Customer Notification

VR4133™

Operating Precautions

Document No. TPS-HE-B-6009-4
Date Published: June 2004

No. 7	Disconnect at the end of PCI burst cycle (Specification change notice)

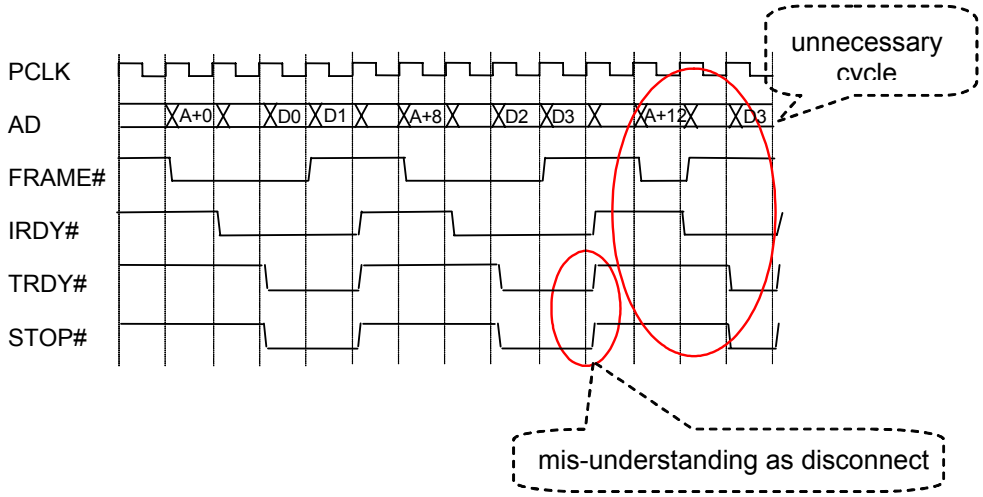
The last transfer of a PCI burst cycle is regarded as a disconnect cycle by VR4133, if STOP# and TRDY# are both asserted during the last-but-one data cycle, as shown in the following figure:

D0 ,D1,D2 are burst data; D3 is last burst data and D2 is last-but-one burst data. TRDY# and IRDY# are both asserted during D2 and D3. So data transfer of D2 and D3 is finished. But because of this restriction, VR4133 mis-interpreting data phase as if it is disconnected at D2. Therefore D3 cycle is performed again.

Therefore one of the following workarounds must be implemented:

(1) Do not use PCI-DMA function.
(2) Do not use LD and SD instructions and do not locate PCI memory and I/O areas in cached memory region of the CPU, so that burst cycles as shown above are not generated.
